**CITY OF FREDERICKSBURG
HISTORIC REVIEW BOARD
TUESDAY, APRIL 12, 2022 @ 5:30 P.M.
LAW ENFORCEMENT CENTER at 1601 E. MAIN ST**

7. CERTIFICATE OF APPROPRIATENESS APPLICATIONS

**HISTORIC REVIEW BOARD
MARCH 15, 2022
5:30 PM**

1927 CRAFTSMAN RENOVATION/REMODEL
OWNERS: PAUL & MONA KNOPP

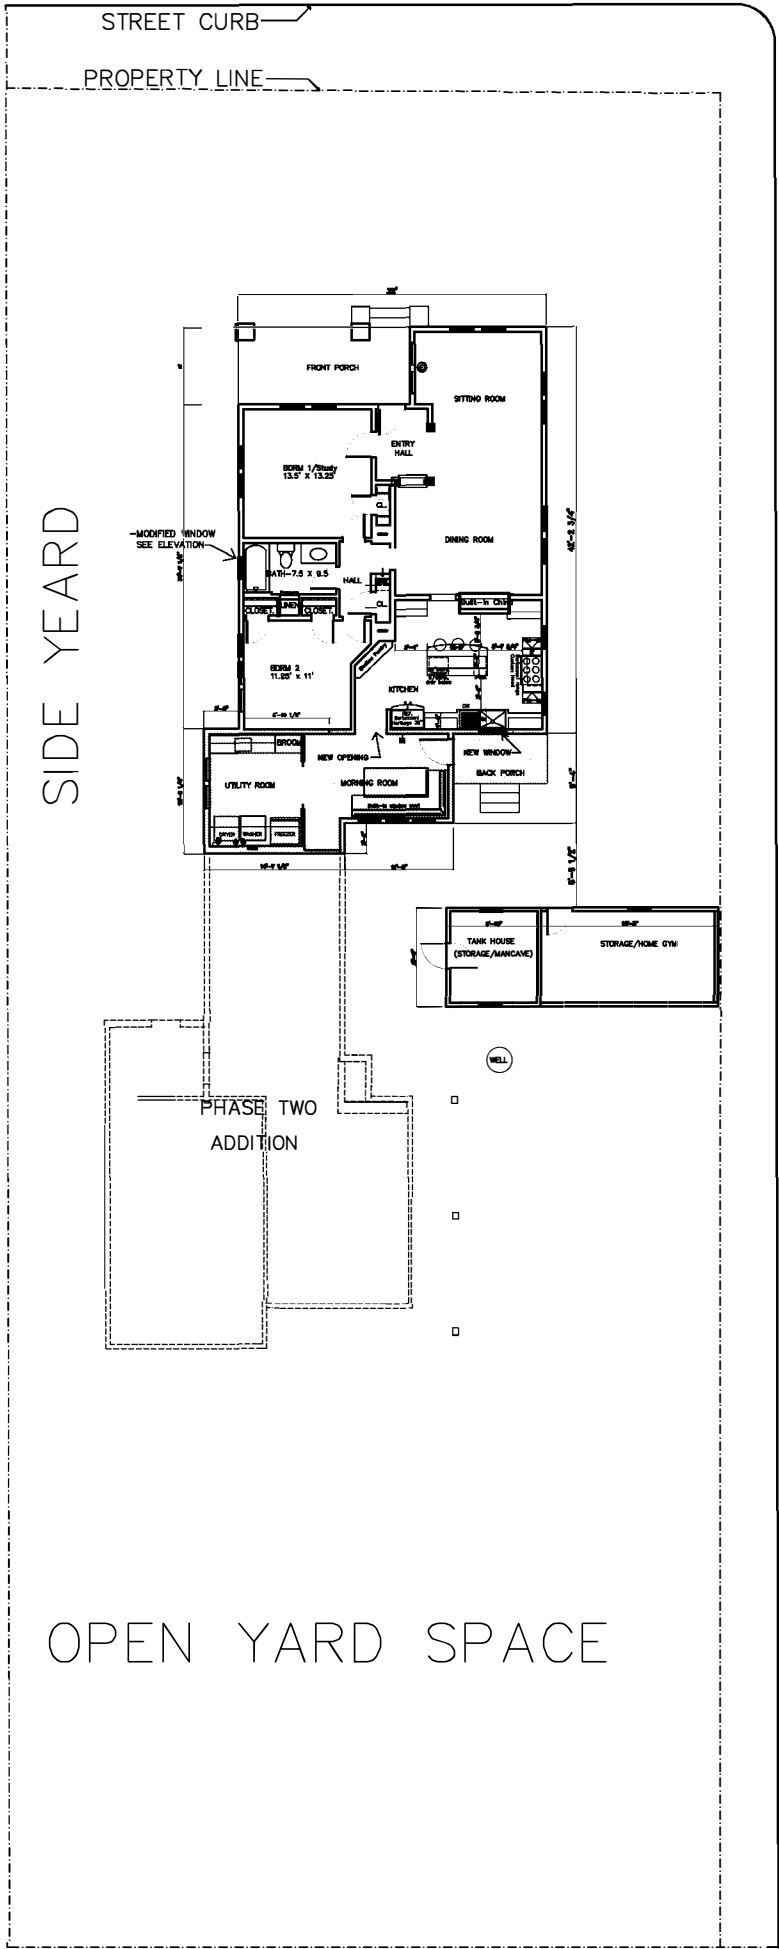
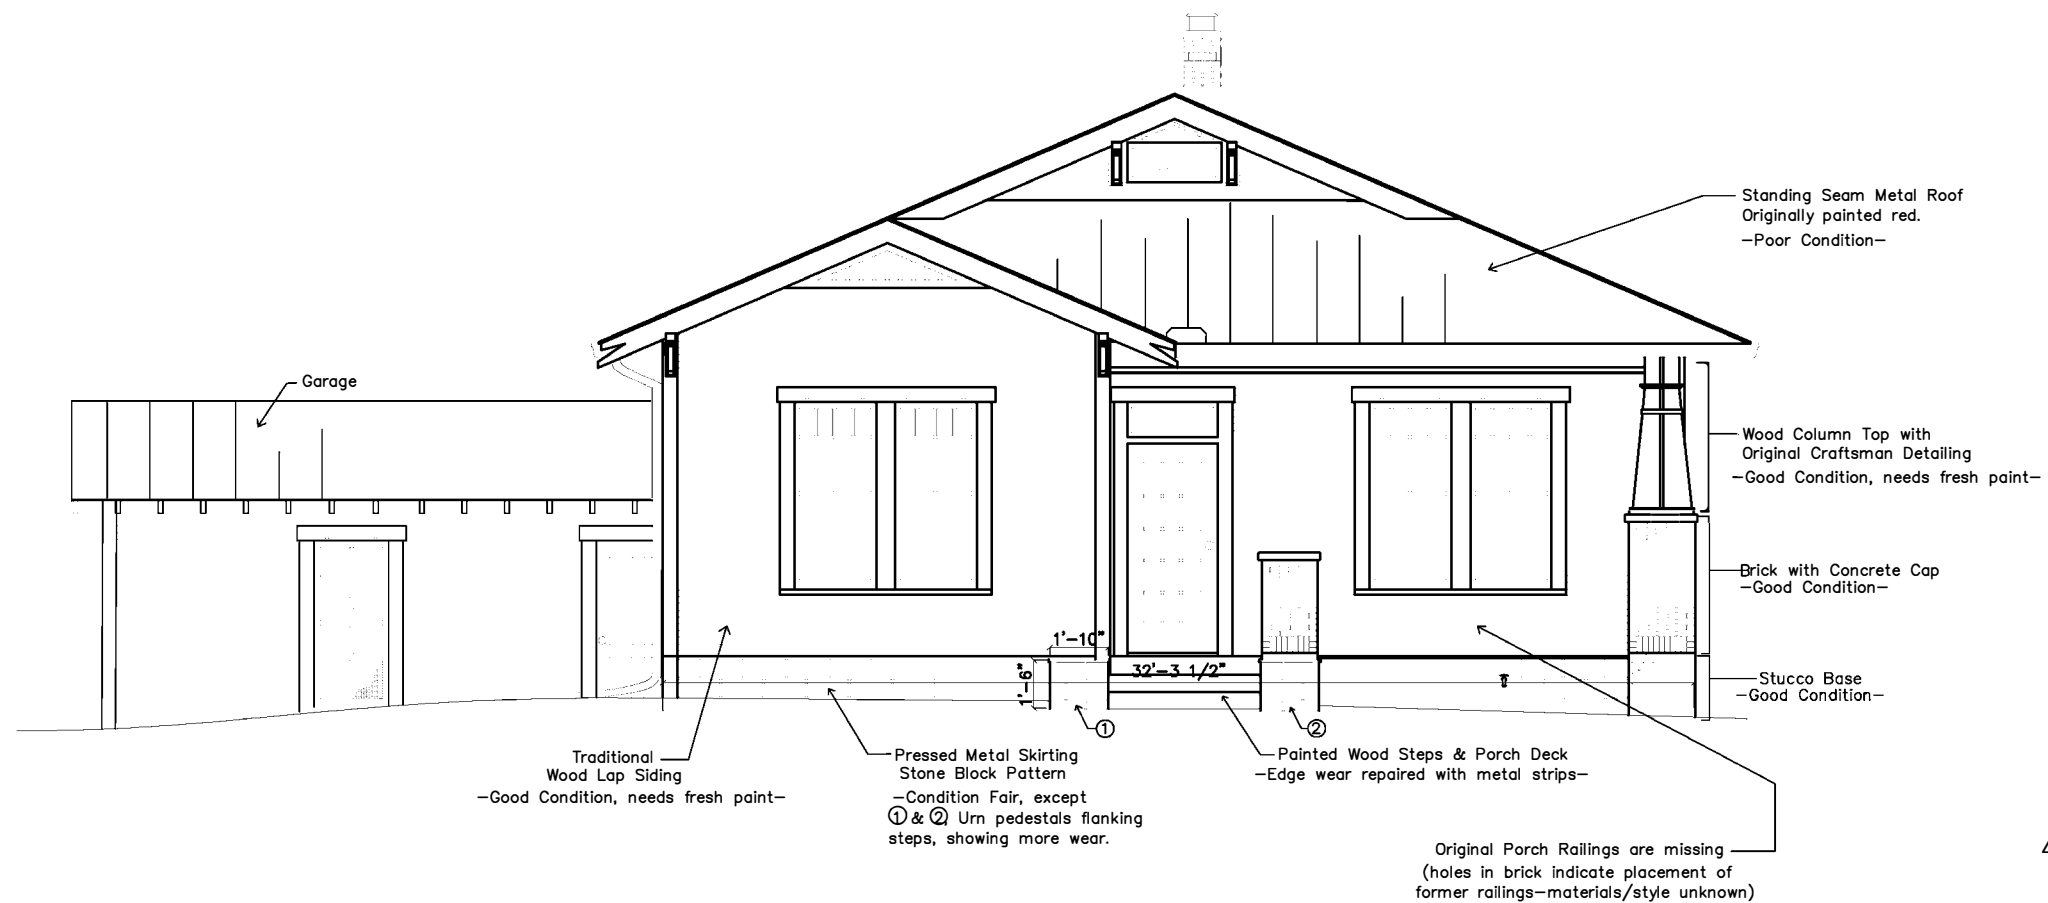
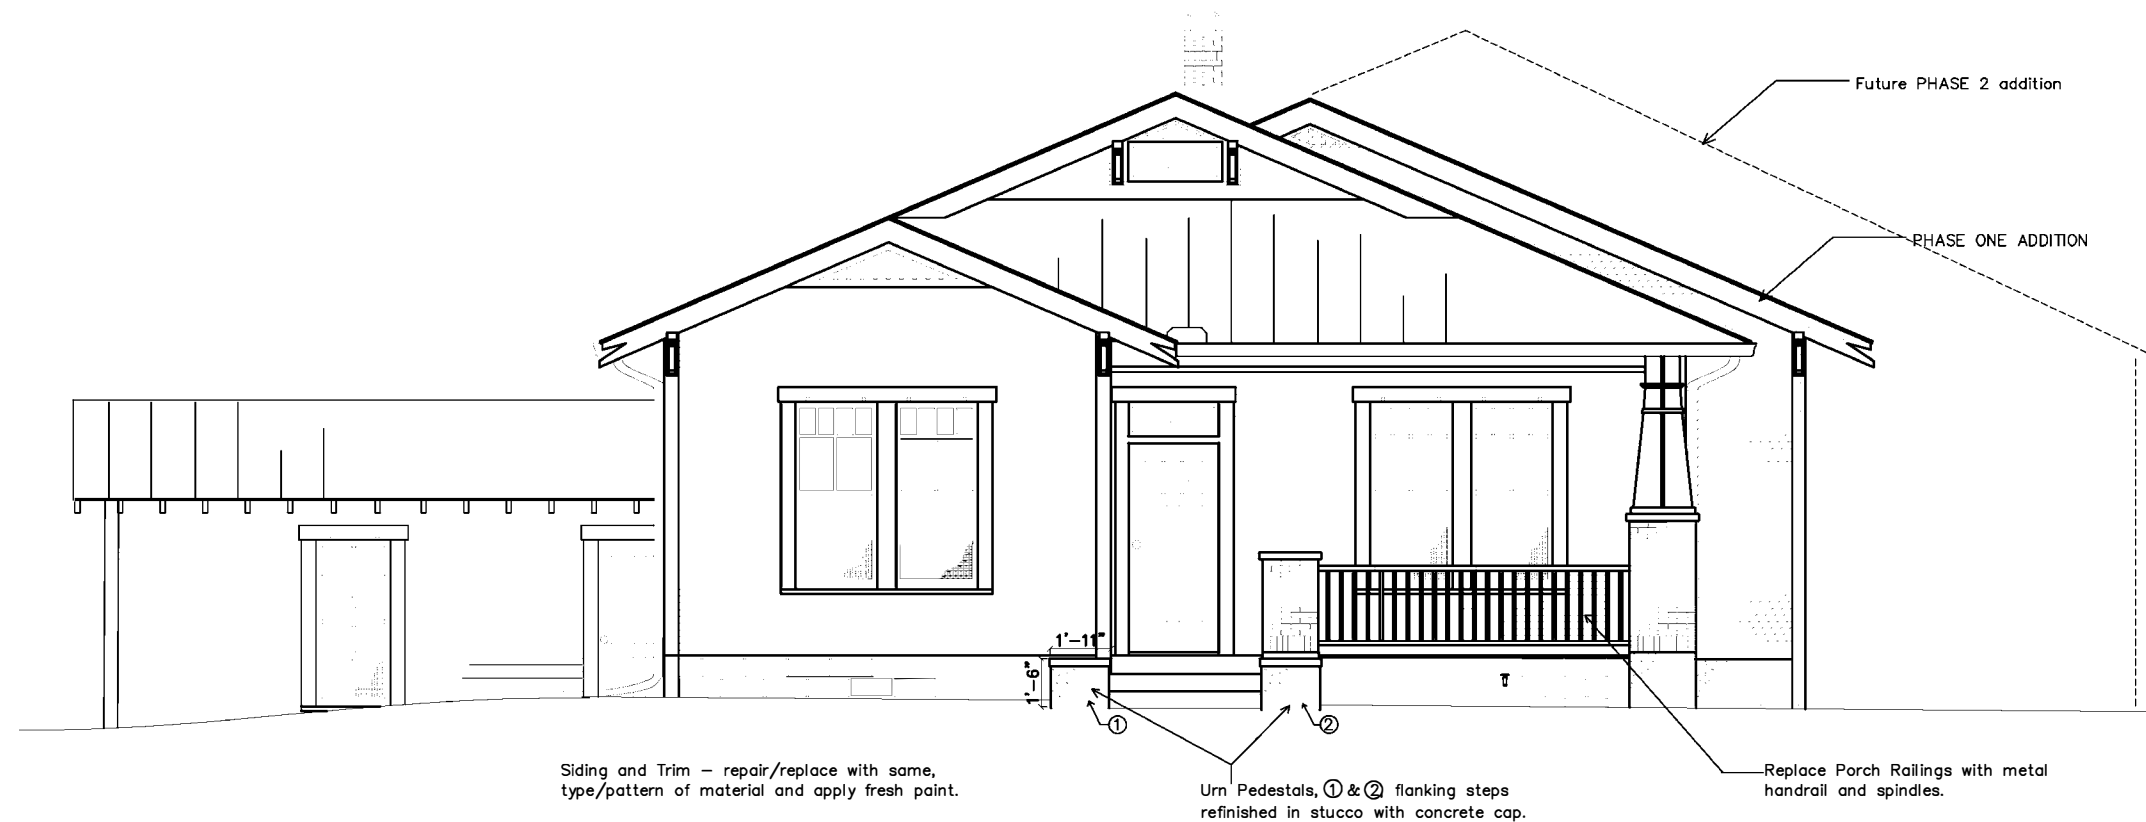
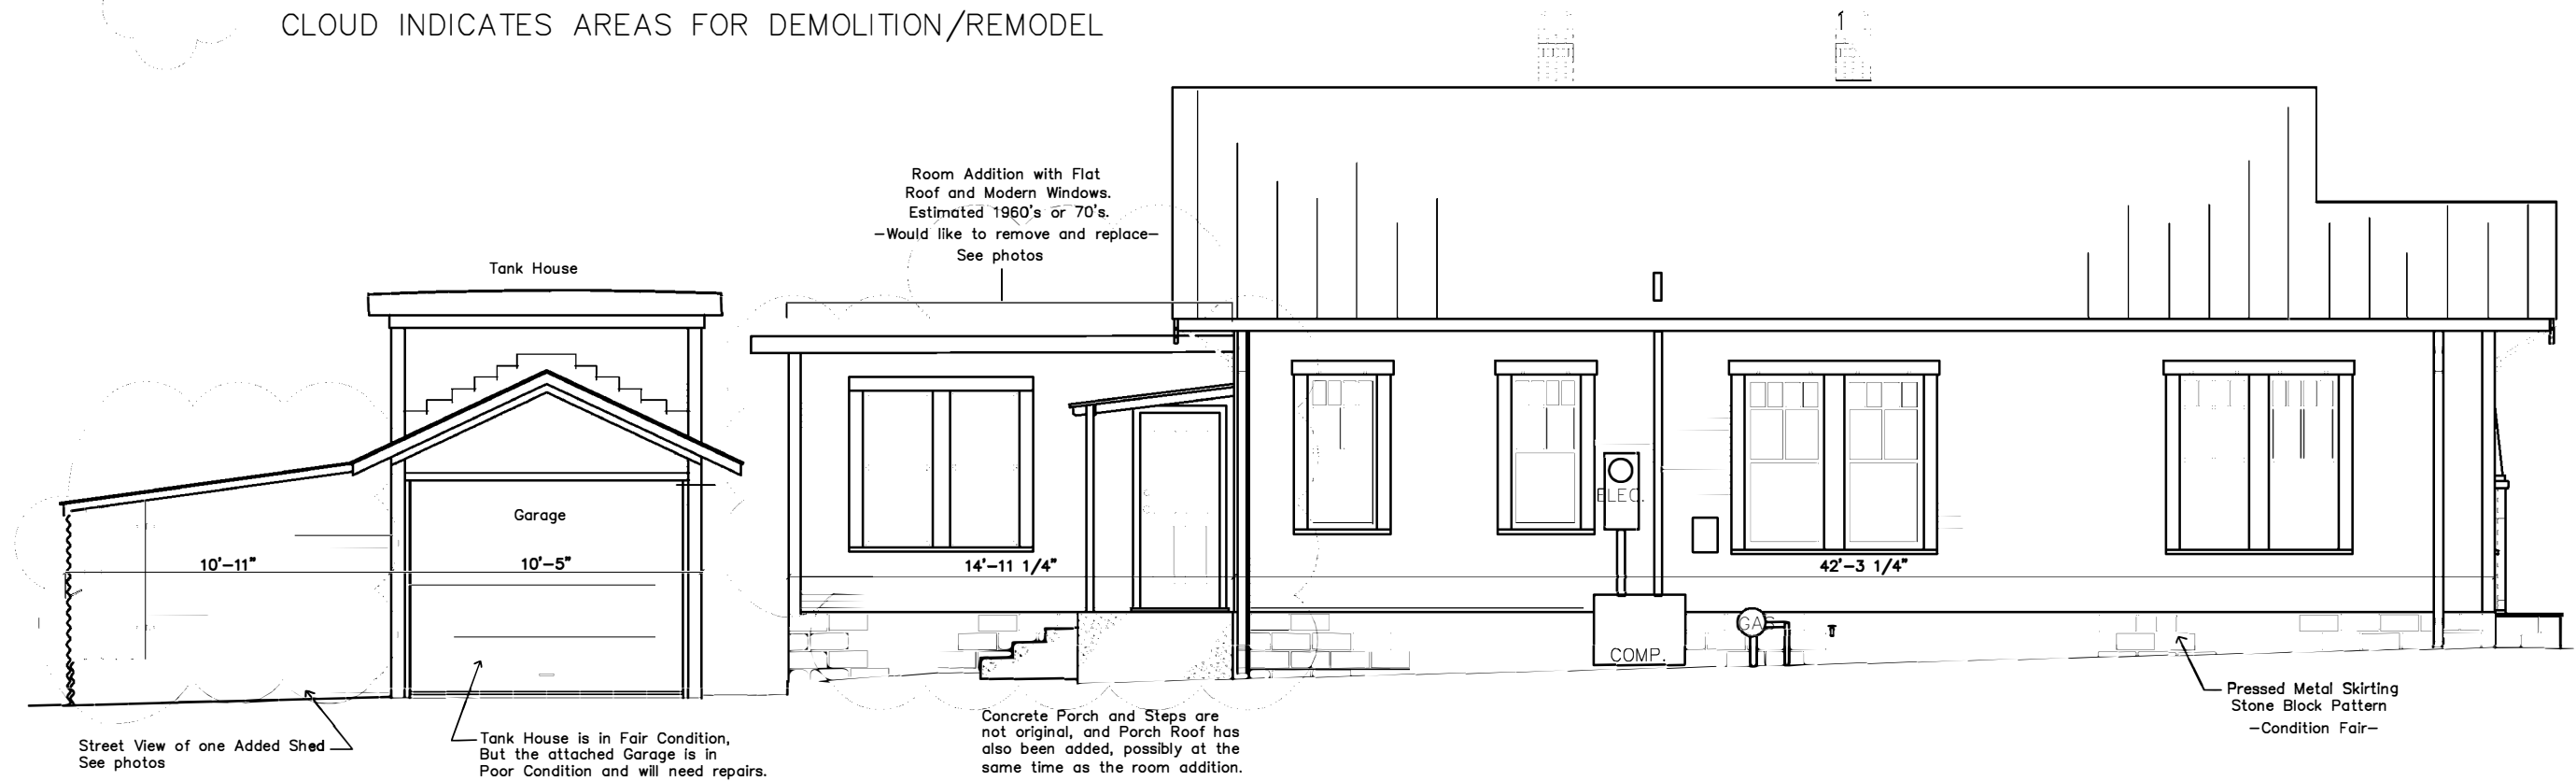
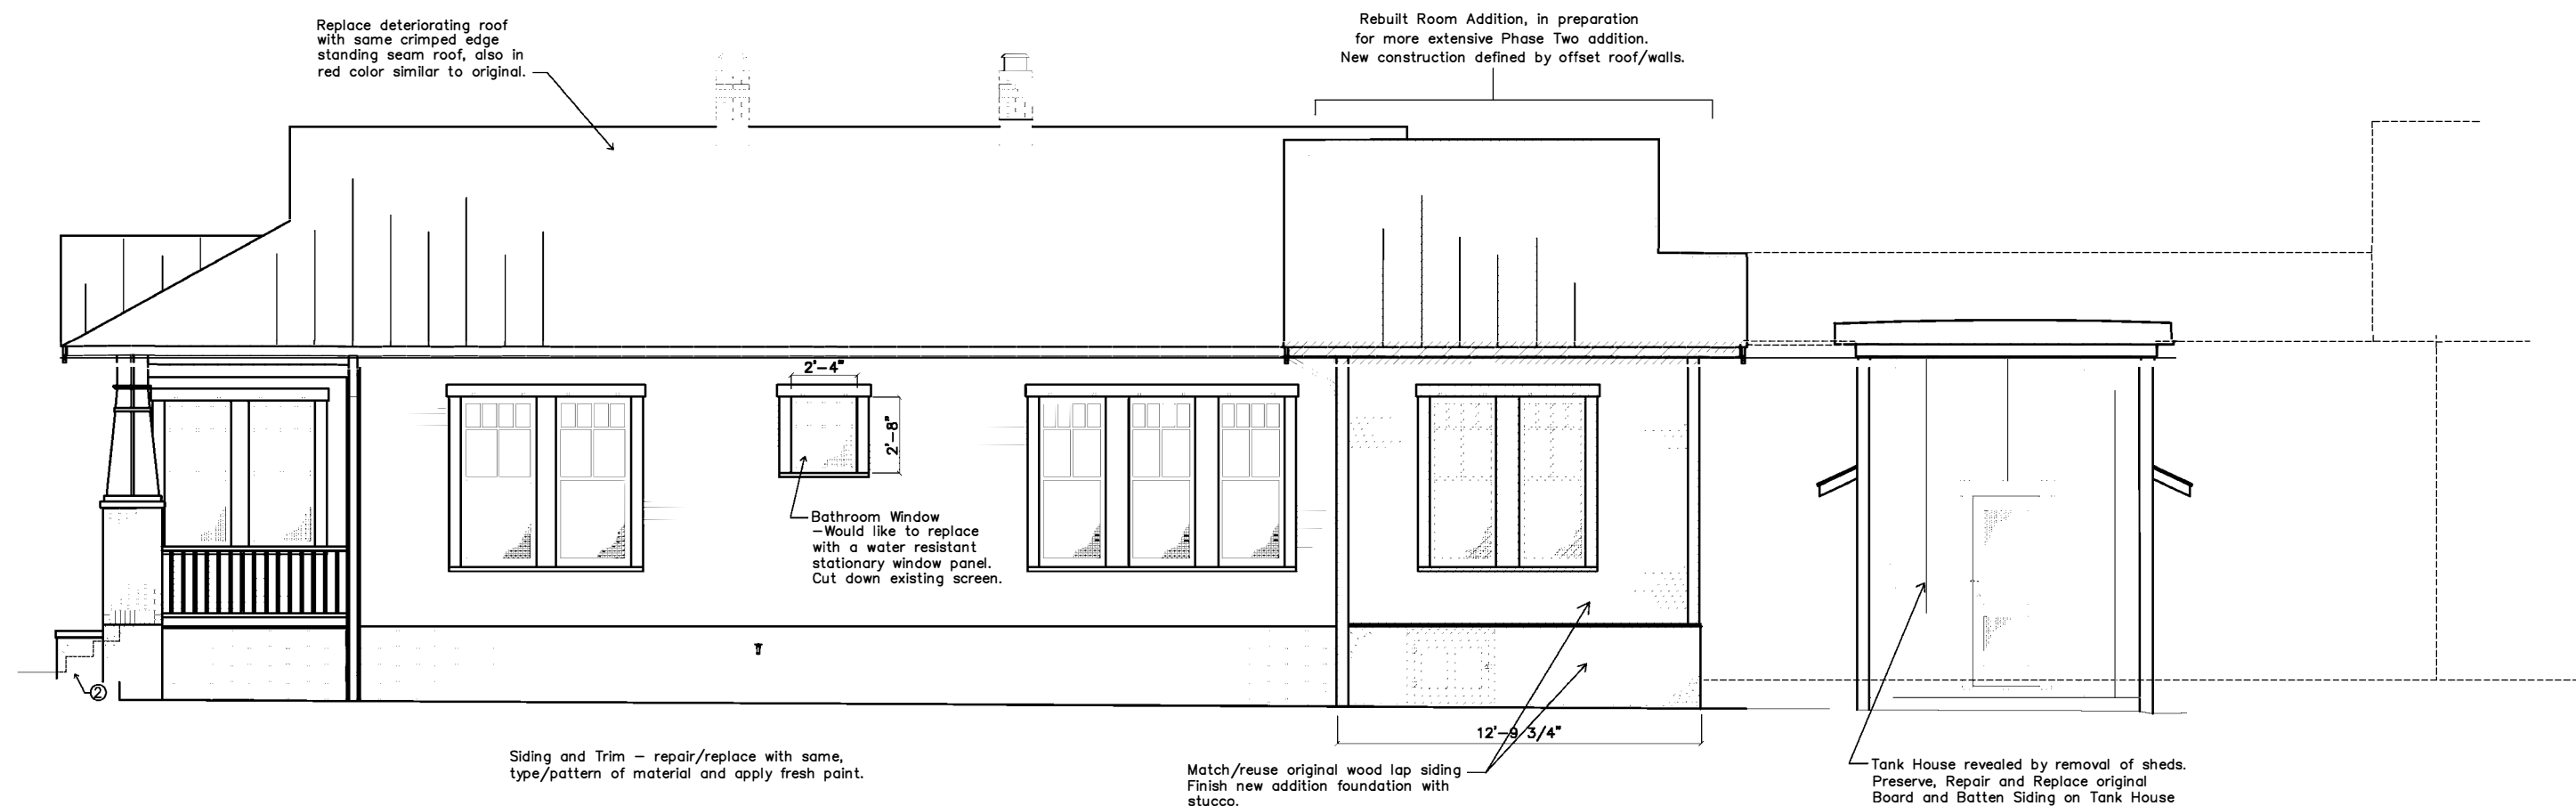
Staff recommends approval of the proposed repairs (items 4, 5, &7). The missing front porch rail should be replaced with a simple wood rail (item 6). The drawing shows a metal handrail.

The window in question is on the interior side of the lot and not readily visible from the street. The proposed re-use of the screen will help maintain the existing window pattern/design. Staff recommends approval of item 9.
